SERVICE BULLETIN M20-278

- SUBJECT:** Wing Flap Actuator Bracket Repair
- MODELS/ S/N** M20M, Serial Numbers 27-0306 thru 27-0311
AFFECTED: M20R, Serial Numbers 29-0247 thru 29-0261, 29-0263, 29-0266, 29-0268 thru 29-0271,
29-0275
M20S, Serial Numbers 30-0056 thru 30-0058

Figure M20-278- 1

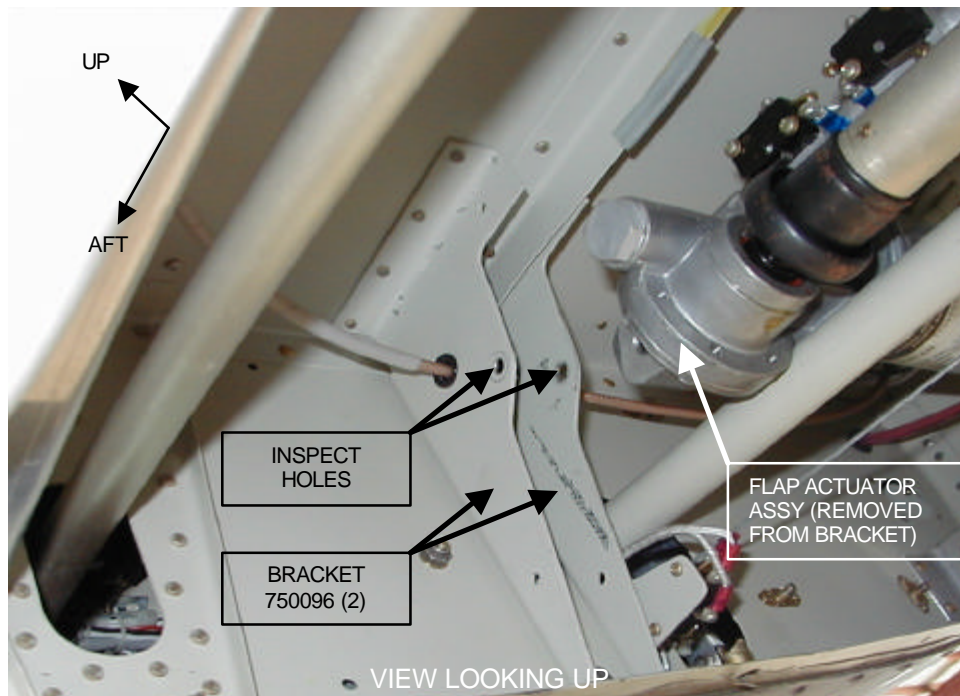
2. Remove actuator mounting bolt and support actuator.
 3. Inspect flap actuator mounting holes (2) in the 750096 bracket (figure M20-278-1).
 - A. If hole size is .250 / .254 no further action or inspection is required; go to step 9.

- B. If hole size exceeds .3125 inch diametrical dimension, replace oversize or damaged 750096 bracket.
 - C. If hole size is not between the 0.250 / 0.254 inch diameter limit, and does not exceed .3125 inch diametrical dimension, proceed with the following steps.

Figure M20-278- 2

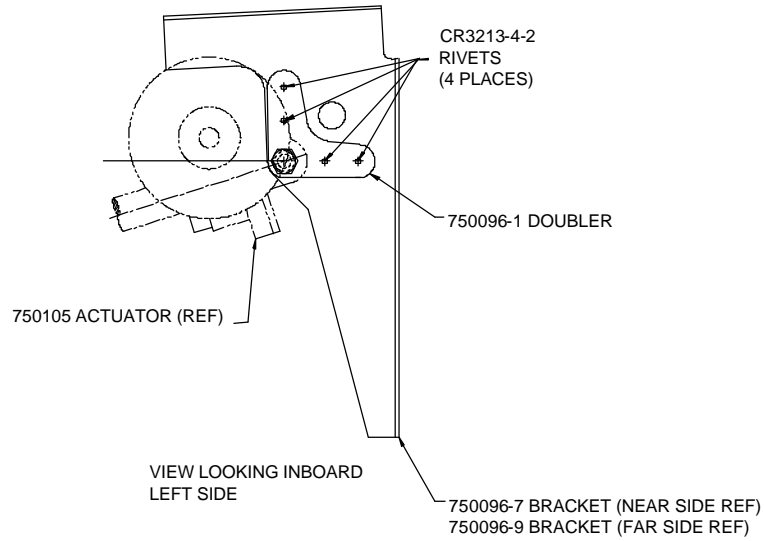
4. Locate 750096-1 doublers as shown in figures M20-278-2 and M20-278-3. Secure doublers with actuator mounting hardware and 914020-29 bushing.
 5. Match drill four #30 drill holes thru the -1 doublers and install CR3213 rivets as shown in figure M20-278-2.

FIGURE M20-278- 3

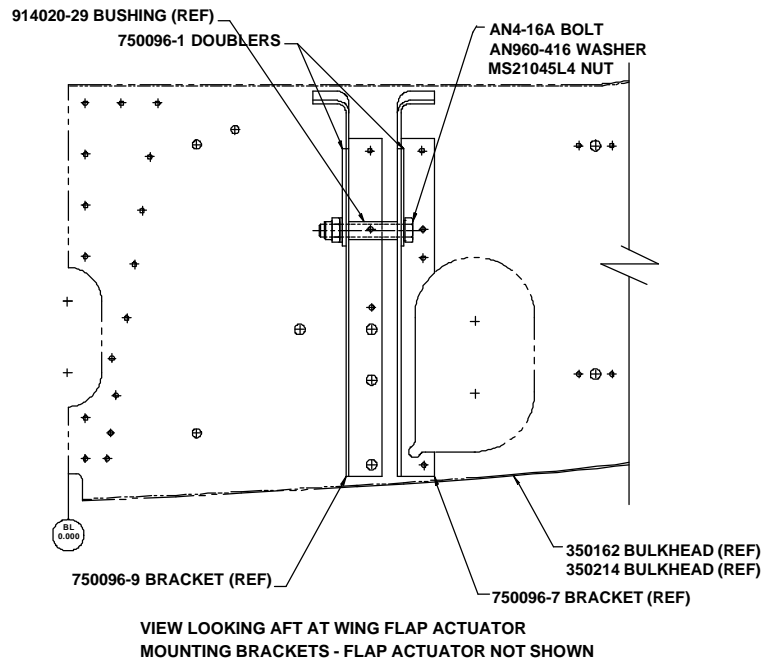
6. Reinstall actuator with new hardware (figures M20-278-3 and M20-278-4).
 7. Inspect area and secure components per good aircraft maintenance practice.
